**TECHNICAL SERVICE BULLETIN****25-2350****"Steering Assist Fault Service Required" Message In The IPC And Reduced Steering Assist With DTCs U3008 And/Or U3009 Stored In The PSCM**

25 July 2025

Ford 2025 Explorer
Lincoln 2025 Aviator

Figure 1

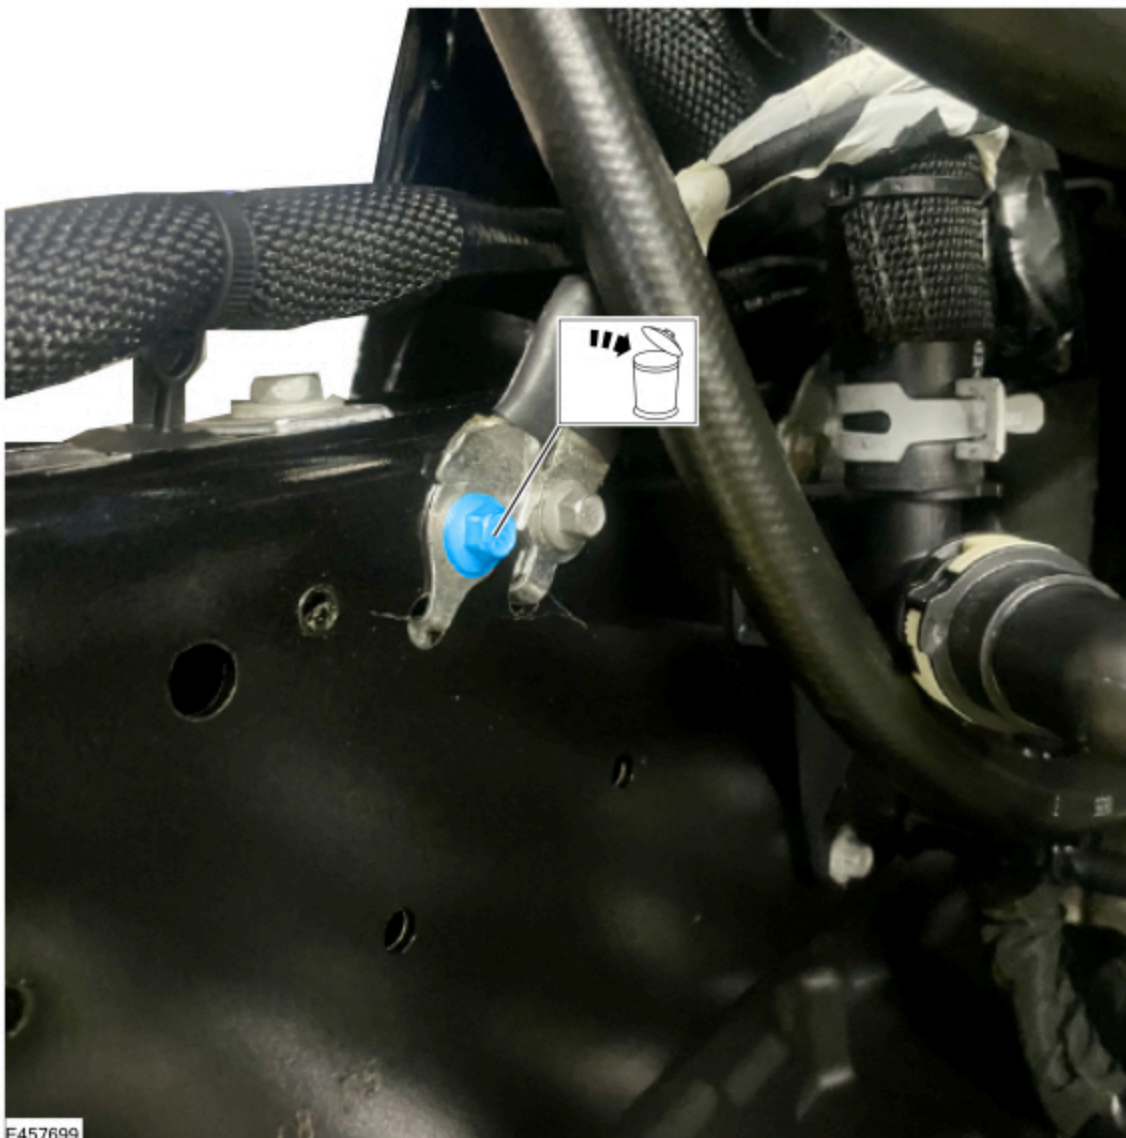
- Using the latest version of the FDRS scan tool, download and run the "Self-Test" application and select "Run ALL CMDTCs". Is DTC U3008 present in the PSCM?
 - Yes - proceed to Step 2.
 - No - proceed to Step 7.
- Remove the engine front undershield. Refer to WSM, Section 501-02 > Removal and Installation > Engine Front Undershield.
- Remove and discard the M6 fastener from ground G104 (Explorer) or G116 (Aviator) on the passenger side frame rail. Refer to Wiring Diagram Cell 151 for connection locations. (Figure 1)

4. Carefully enlarge the existing holes in the frame rail sheet metal and the harness eyelet by drilling with a 7 mm (9/32 in.) drill bit.
5. Reinstall ground G104 (Explorer) or G116 (Aviator) using the new self-tapping M8 fastener. Make sure the ground eyelet locating tab is properly aligned with the alignment hole in the frame. Tighten to 71+/-11 lb.in (8.0+/-1.2 Nm).
6. Install the engine front undershield. Refer to WSM, Section 501-02 > Removal and Installation > Engine Front Undershield.
7. Using FDRS, download and run the "Self-Test" application and select "Run ALL CMDTCs". Is DTC U3009 present in the PSCM?
 - (1). Yes - proceed to Step 8.
 - (2). No - repair is complete. If further diagnosis is necessary, refer to WSM, Section 211-02 > Diagnosis and Testing.
8. On Aviator vehicles, remove the wiring harness retainer from the ground G119 stud bolt to access the bolt. (Figure 2)

Figure 3

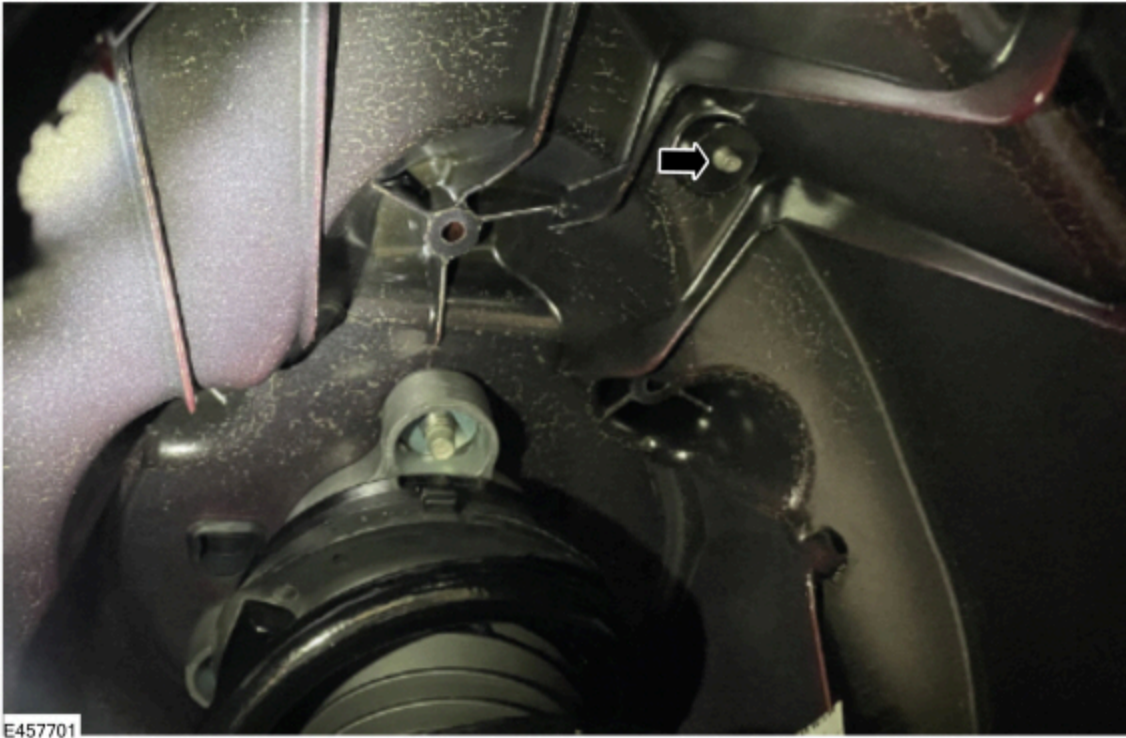
9. Remove the right front wheel and tire. Refer to WSM, Section 204-04A > Removal and Installation > Wheel and Tire.
10. Install the new M6 nut on the existing fastener on ground G103 (Explorer) or G119 (Aviator) on the passenger side strut tower. Tighten to 106+/-16 lb.in (12.0+/-1.8 Nm). (Figure 3)
